Subject: Aux-Drive Gear Bearing Change / 13-Speed MHP Models

Document Number: TAIB0867 EN-US

Date: January 22, 2018

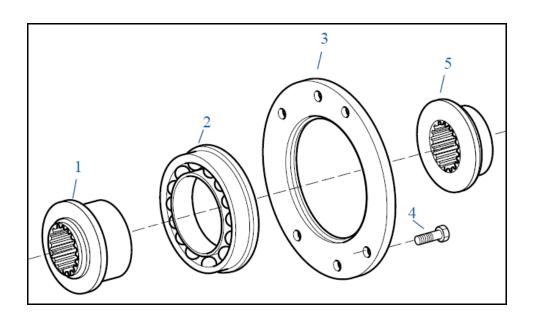
Issue Description: 13-speed MHP models built after 3/20/17 now use a 5566508 aux-drive gear bearing in place of the 5566510. Due to the dimensional differences of these two bearings, the following parts were also used to accommodate this change.

The following parts will be needed if an S-3121 (4306036) service case is used on a transmission originally built with a 4308734 case.

- Bearing spacer 4306314 (item 1)
- Bearing 5566510 (item 2)
- Retainer 4304497 (item 3)
- Drive gear spacer 4304500 (item 5)
- Cooler port adapter kit K-4292
